HISTORIC AND DESIGN REVIEW COMMISSION

September 19, 2018

HDRC CASE NO: 2018-454
ADDRESS: 1950 W MAGNOLIA AVE
LEGAL DESCRIPTION: NCB 1961 BLK 9 LOT 14 & P-105 (PT OF ALLEY)
ZONING: R-6 H
CITY COUNCIL DIST.: 7
DISTRICT: Monticello Park Historic District
APPLICANT: Bob Bradley
OWNER: John Hamilton
TYPE OF WORK: Installation of a new front porch element
APPLICATION RECEIVED: August 31, 2018
60-DAY REVIEW: October 30, 2018

ALTERATIONS TO
FRONT PORCH -
NEW ENTRY ROOF

OPTION A

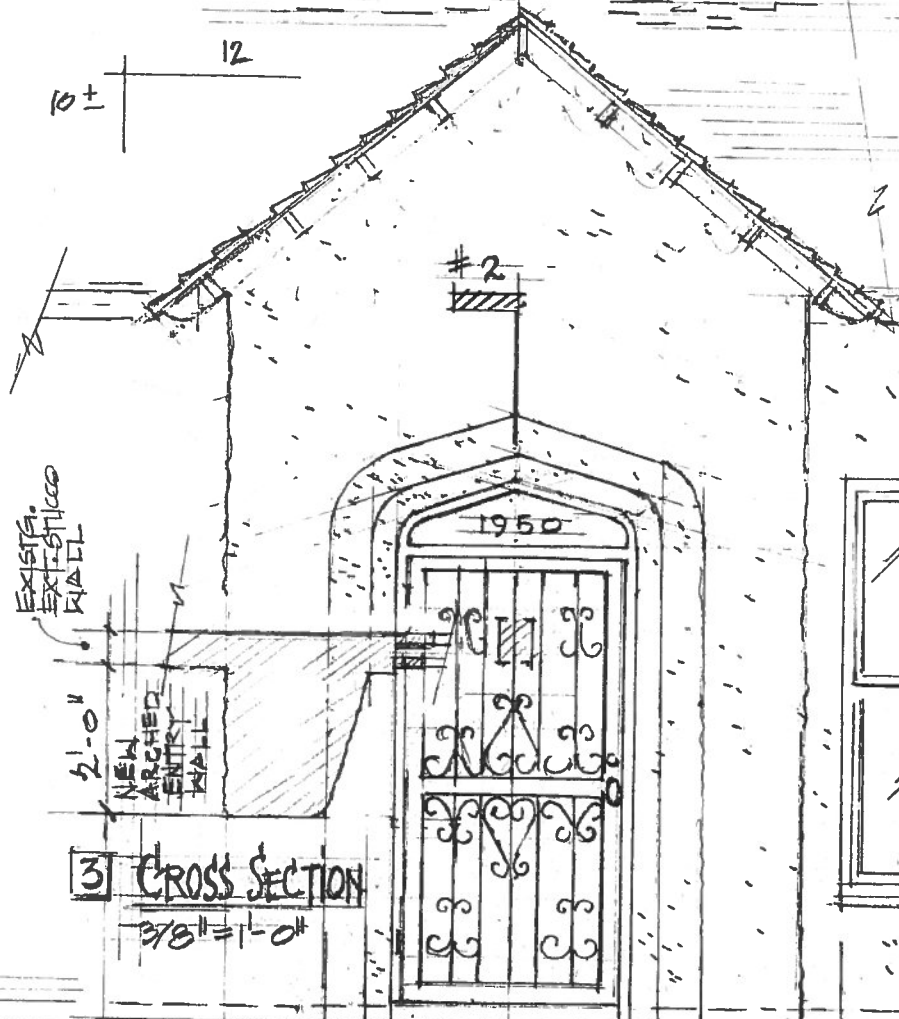
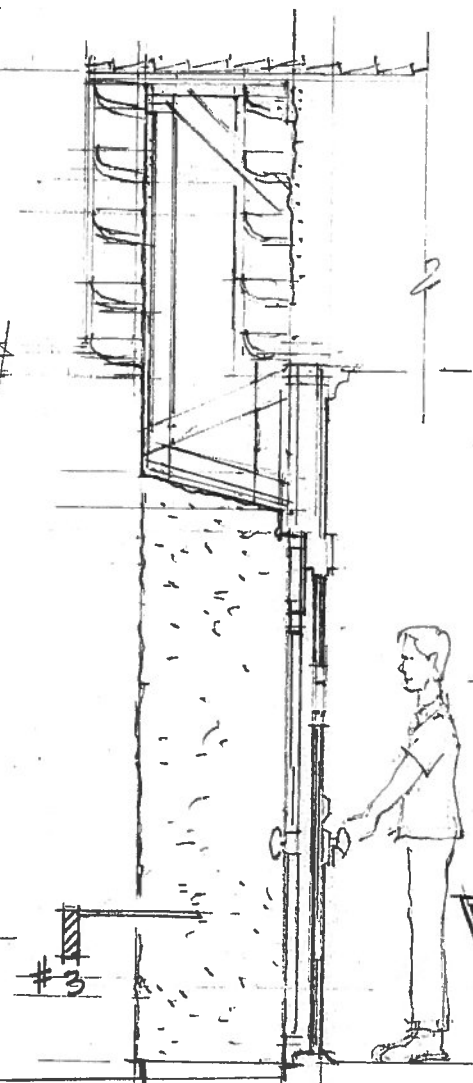
- c. **FRONT PORCH PROPOSAL: OPTION A** – The applicant has proposed to install an extension surrounding the front door to create a covered entry condition. The proposal includes framing the front door with stucco with a depth of about one foot. According to the Historic Design Guidelines, new elements should not obscure character defining elements, nor convey a false sense of history. While the proposal does not obscure any character defining elements, its design and material treatment create a condition that may read as original to the structure. The proposal is also not easily reversible. Staff recommends that the applicant pursue Option B submitted.

Staff recommends approval of Option B, the attached porch awning element, based on findings a through d.

OPTION B

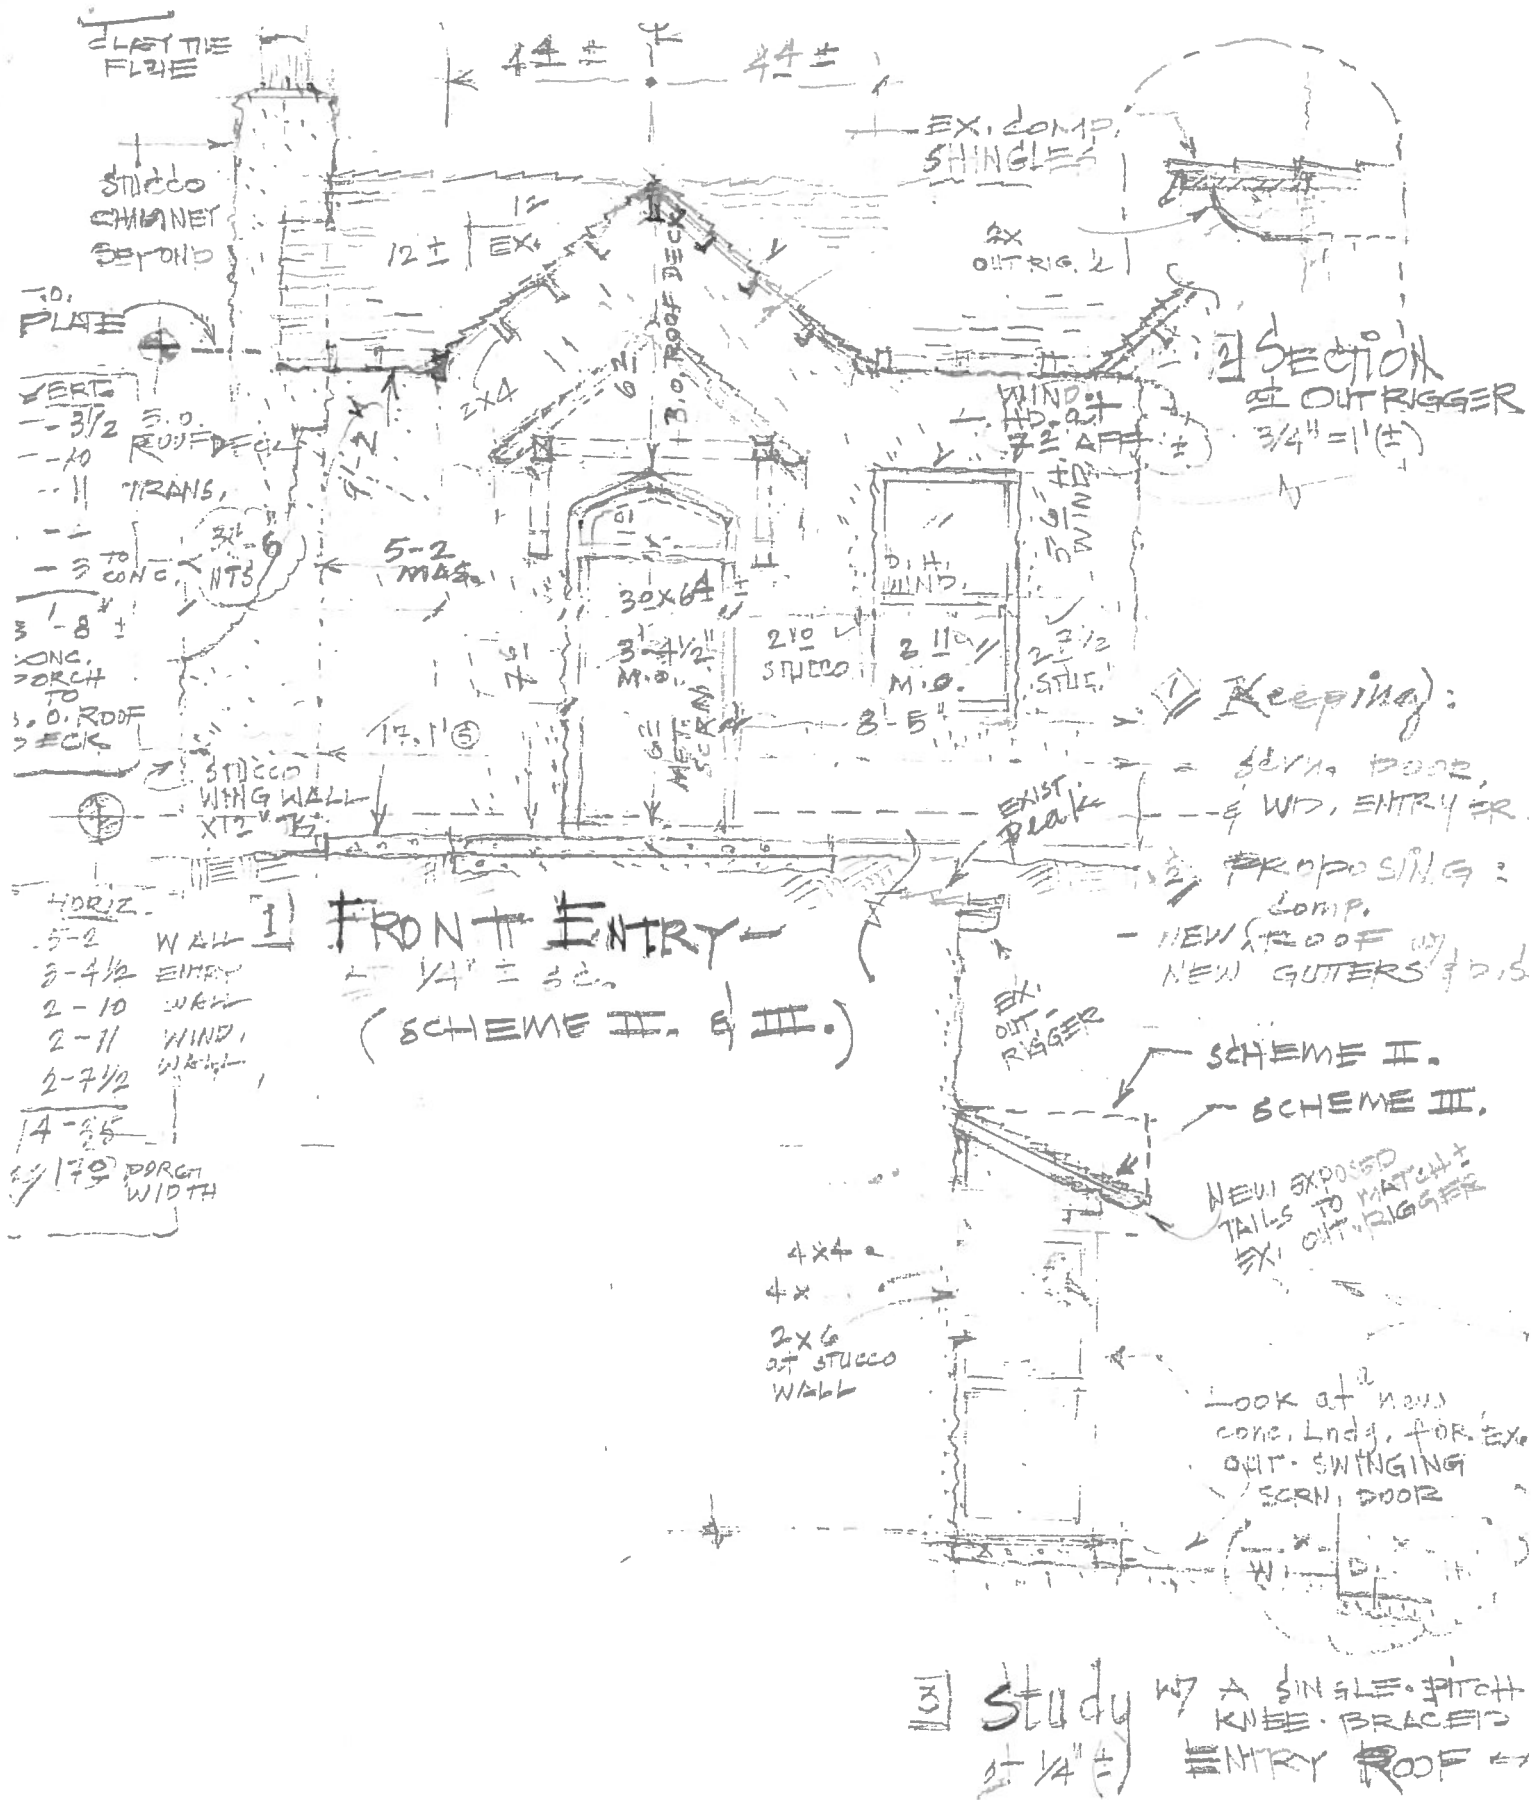
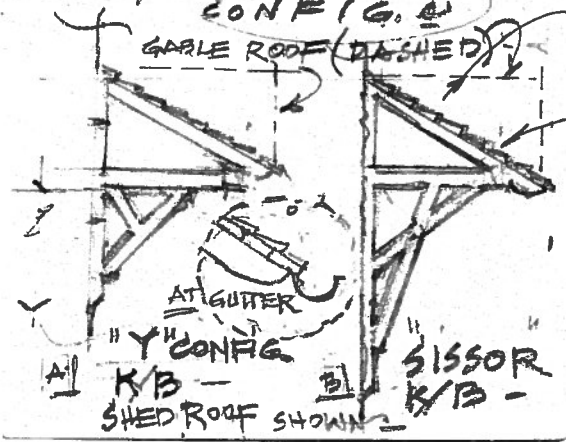
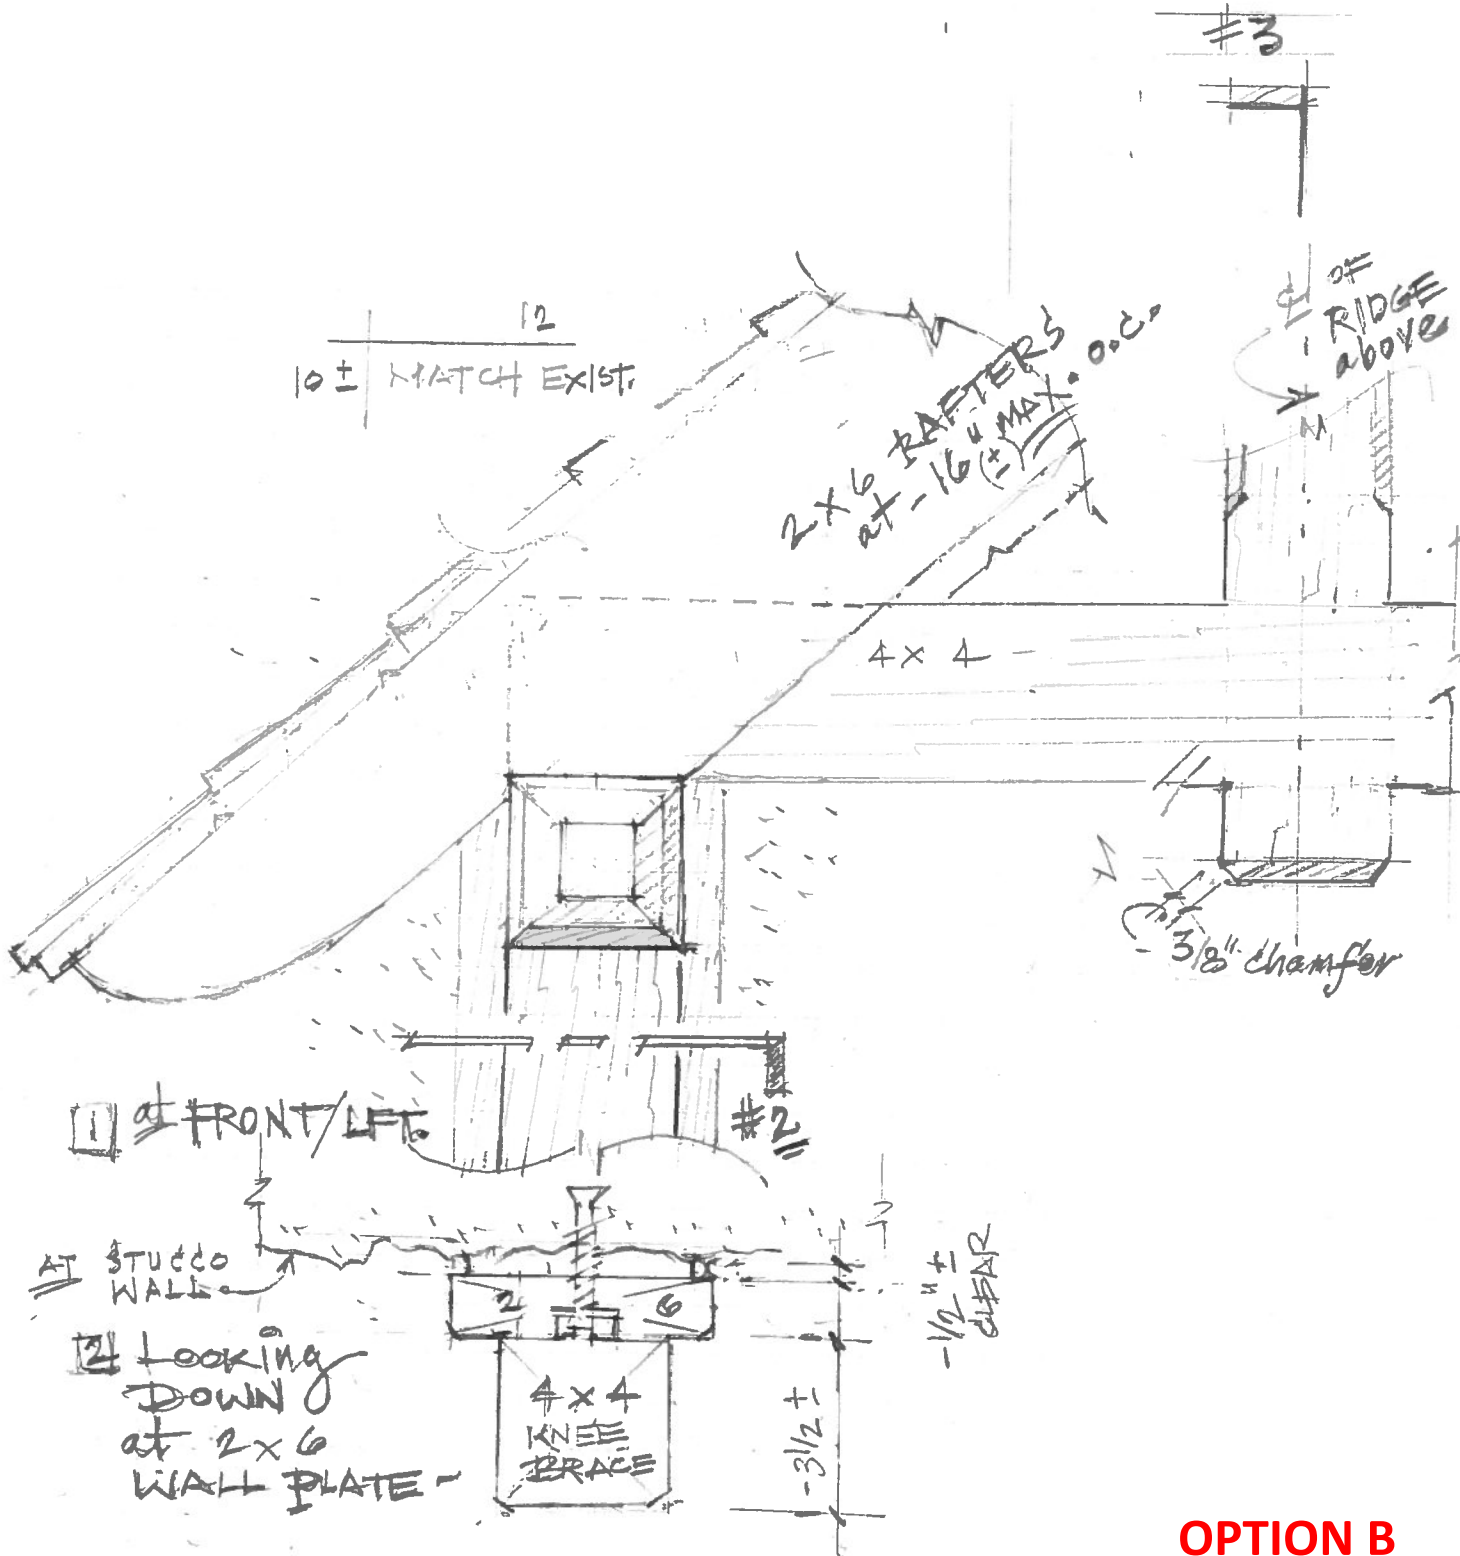
- d. **FRONT PORCH PROPOSAL: OPTION B** – The applicant has proposed to install a shed awning structure above the existing arched doorway. The canopy will be approximately 3” in thickness and be made of a UV resistant fabric awning material or a lightweight metal in a color that complements the gray and blue color scheme of the existing home. The canopy will project approximately 2’-6” from the front façade to provide shade and rain protection. According to the Historic Design Guidelines, new elements should not obscure character defining elements, nor convey a false sense of history. This approach does neither and will be installed in a way that is reversible. The proposal responds to the existing geometry of the architecture and is a minimal element that will not detract from significance of the historic material. Staff finds the proposal consistent with the Guidelines.
